## HILL VALLEY - PHASE 2B

CITY PROJECT NO. 15860  
CONTRACT NO. 9680

#### REVISION 1 - 04/29/26

#### REVISION 2 - 05/28/26

PLAN & PROFILE - ENCHANTMENT ROAD  
 HILL VALLEY - PHASE 2B

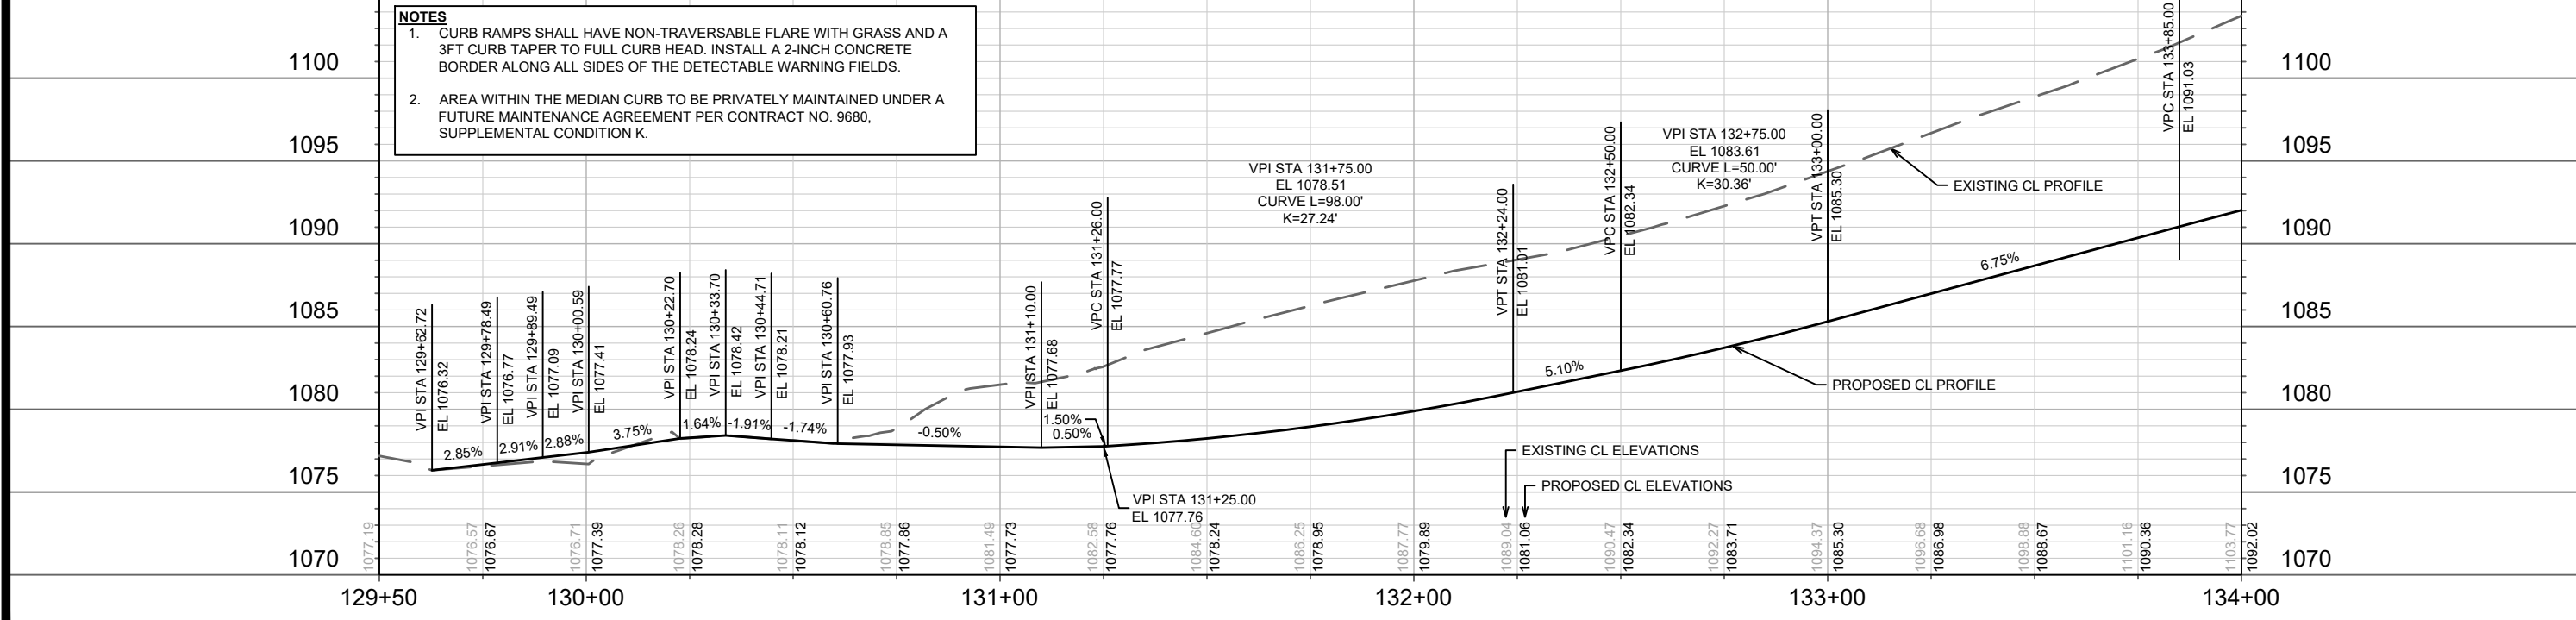
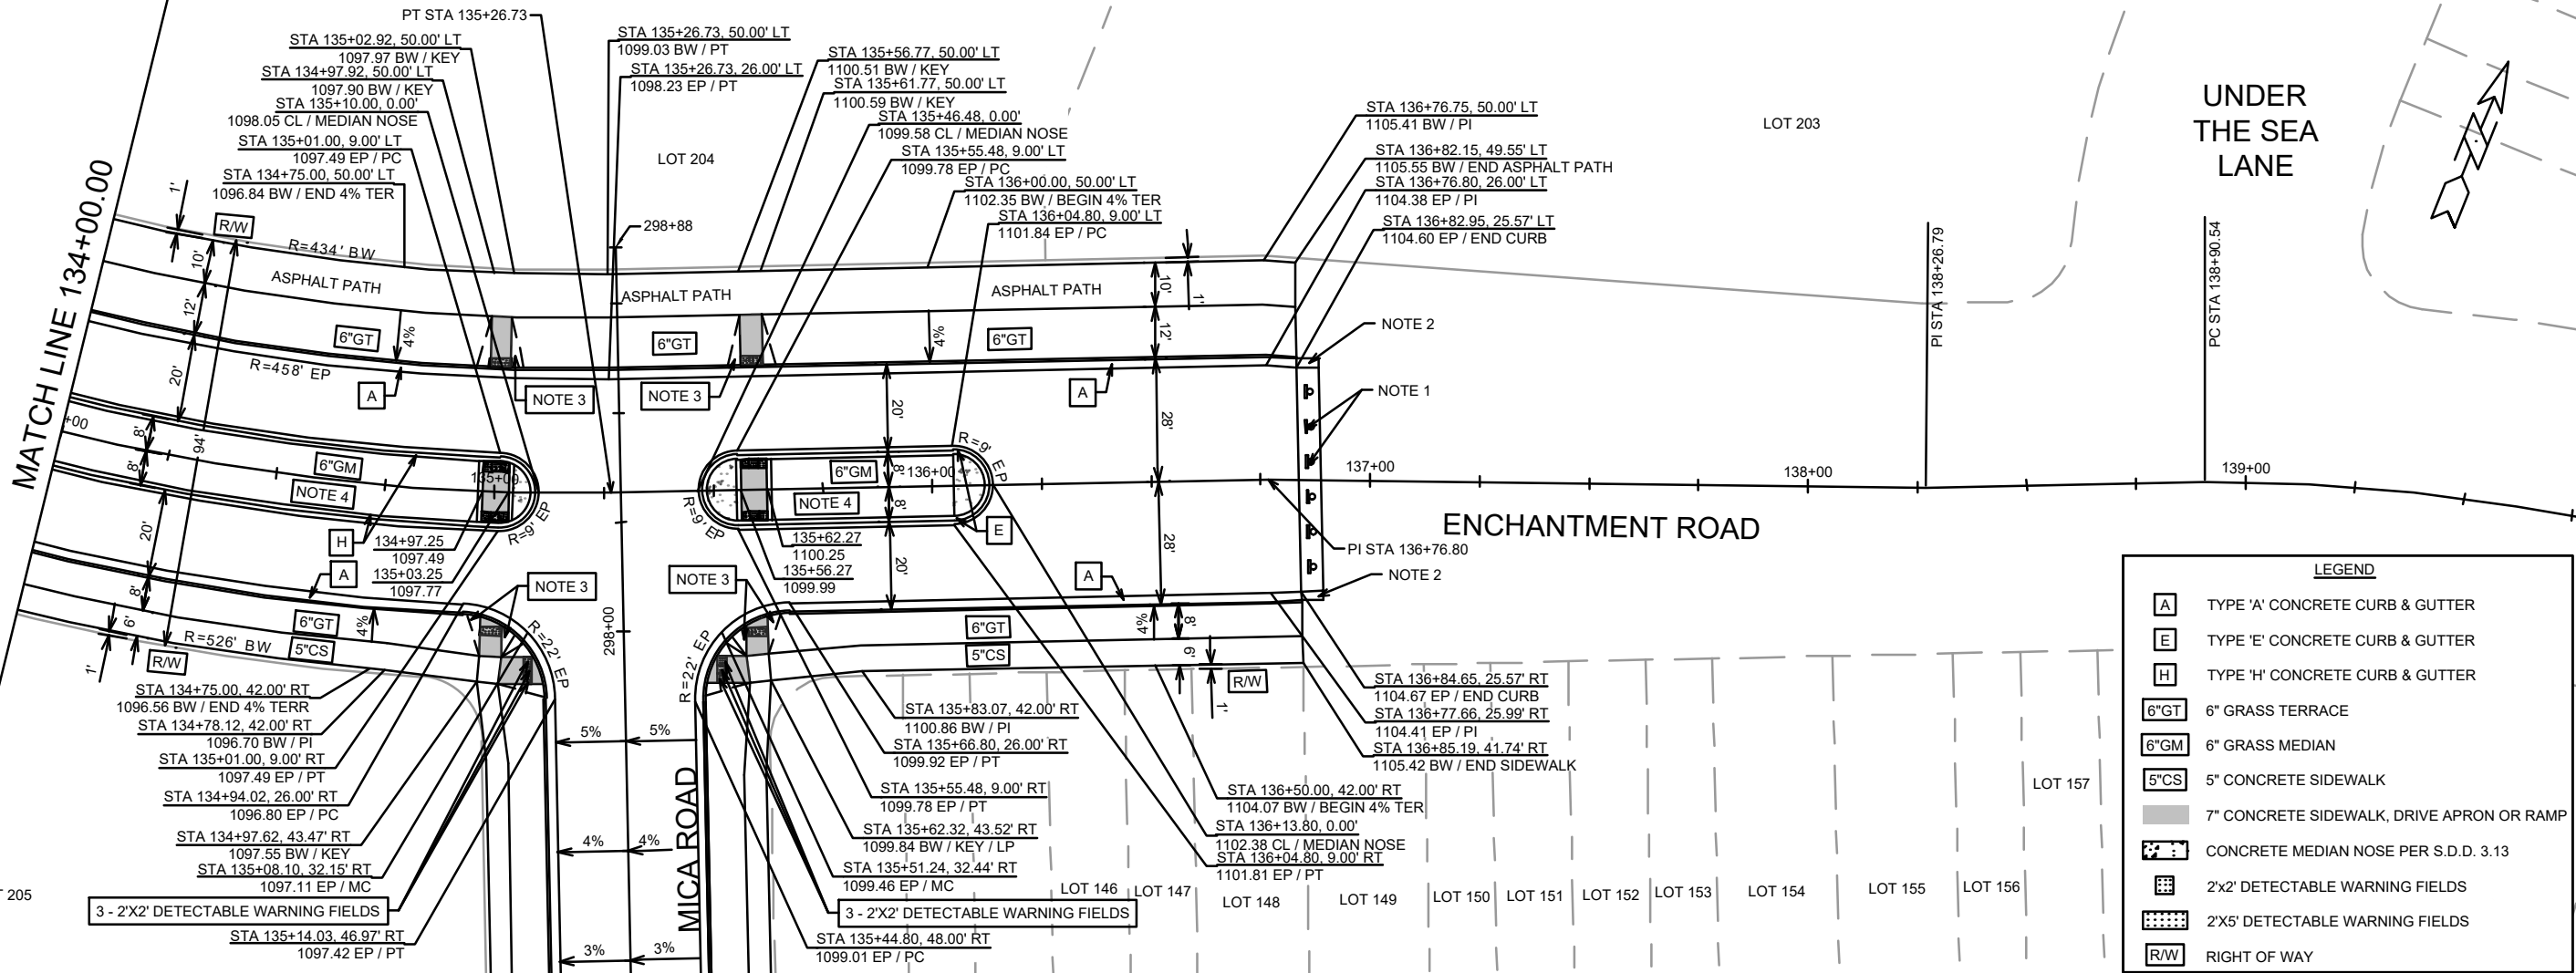
**REVISION 2 - GCIT - 05/28/26**  
 - UPDATED PAVEMENT RESTORATION LIMITS  
 - UPDATED LEGEND

15860  
 MADISON, WI  
 9680  
 CONTRACT NO:  
 PLAN & PROFILE - S PLEASANT VIEW ROAD  
 HILL VALLEY - PHASE 2B  
 M:\DESIGN\Projects\15860\CAD\Streets\15860EN-PnP.dwg

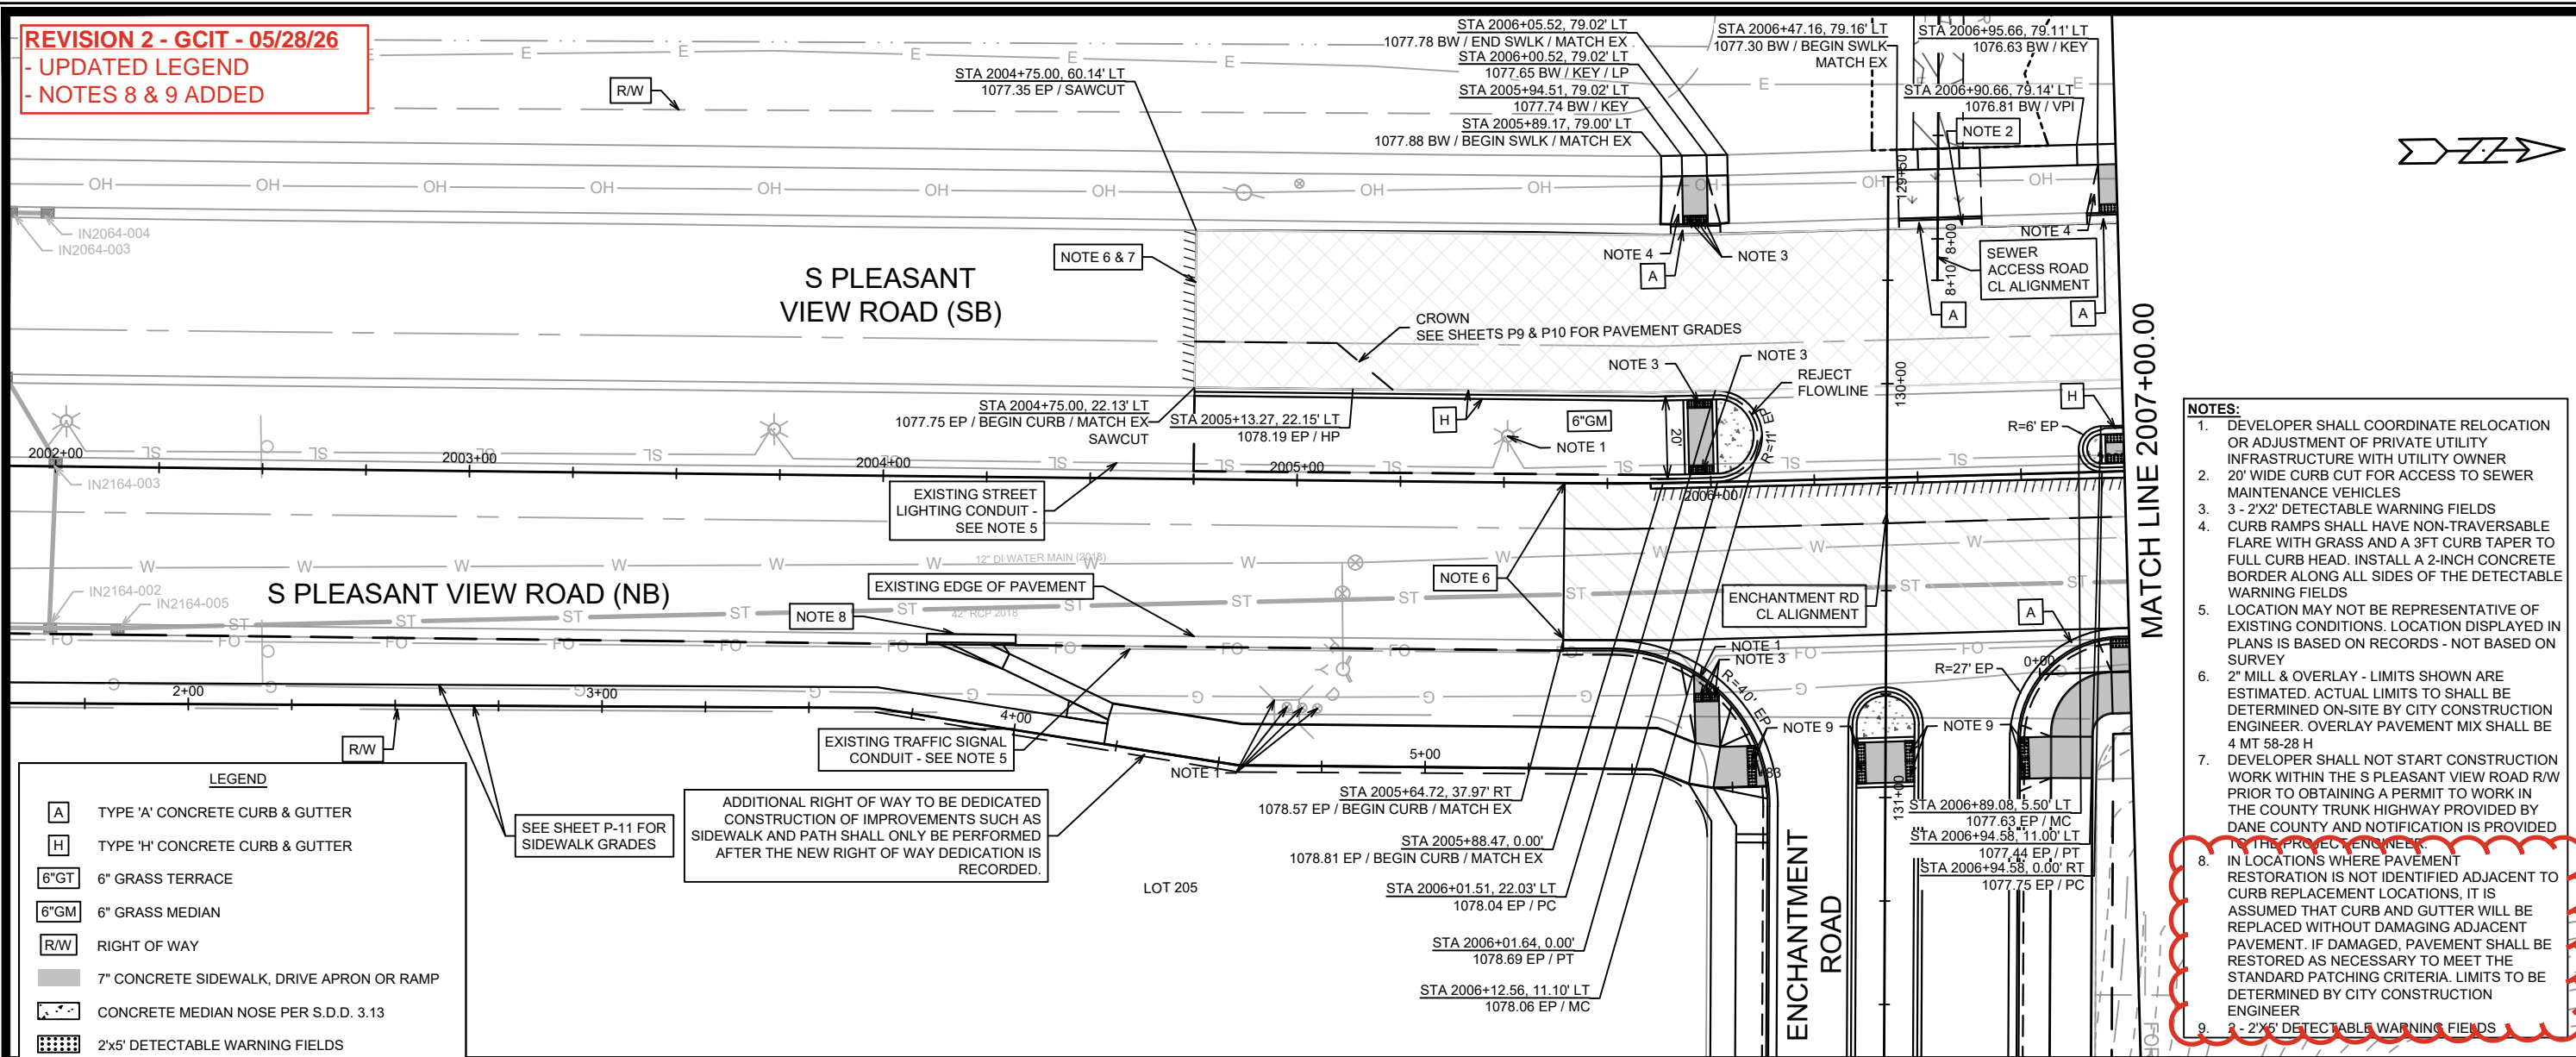
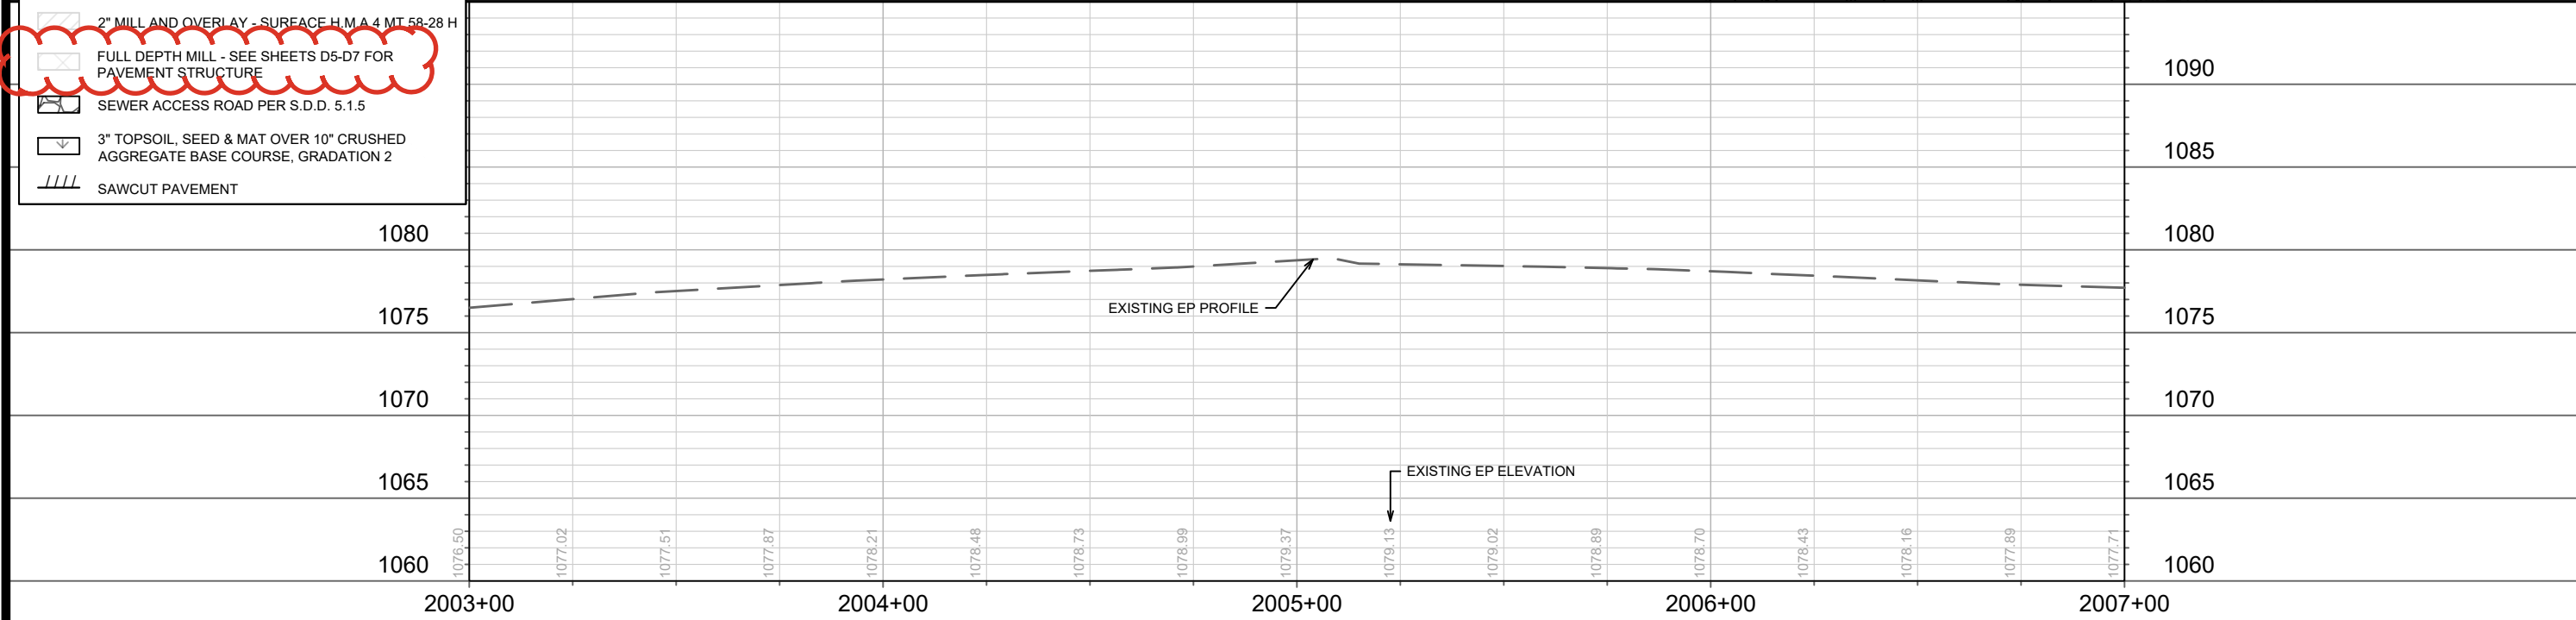
**REVISION 2 - GCIT - 05/28/26**  
 - UPDATED LEGEND  
 - NOTES 8 & 9 ADDED

8. IN LOCATIONS WHERE PAVEMENT RESTORATION IS NOT IDENTIFIED ADJACENT TO CURB REPLACEMENT LOCATIONS, IT IS ASSUMED THAT CURB AND GUTTER WILL BE REPLACED WITHOUT DAMAGING ADJACENT PAVEMENT. IF DAMAGED, PAVEMENT SHALL BE RESTORED AS NECESSARY TO MEET THE STANDARD PATCHING CRITERIA. LIMITS TO BE DETERMINED BY CITY CONSTRUCTION ENGINEER

9. 3 - 2'x5' DETECTABLE WARNING FIELDS
